Changed design and control of the electric actuator

Vehicle Manufacturer: Ford

Vehicle: Transit, Tourneo 2.2 TDCi

BTS reference: T916549, T917549

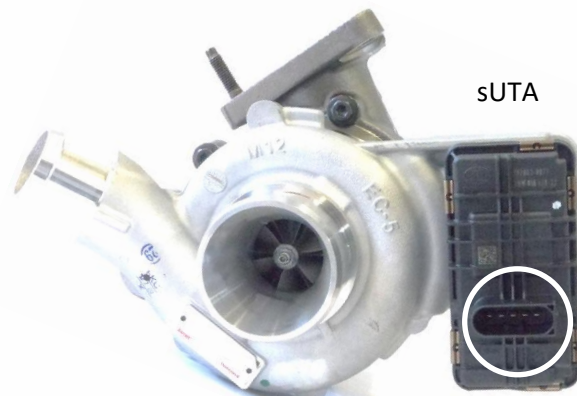
The vehicle manufacturer has carried out during the production period technical changes to the electronic control of the electric actuator on the turbocharger.

The two turbochargers shown must not be reversed, even if the plug of the vehicle will fit on both turbochargers. Due to the different control of the actuator it comes to malfunction and damage the new turbocharger. A warranty is excluded by the manufacturer.

Before installing the new turbocharger you have to compare the design of the e-actuator with the old turbocharger.
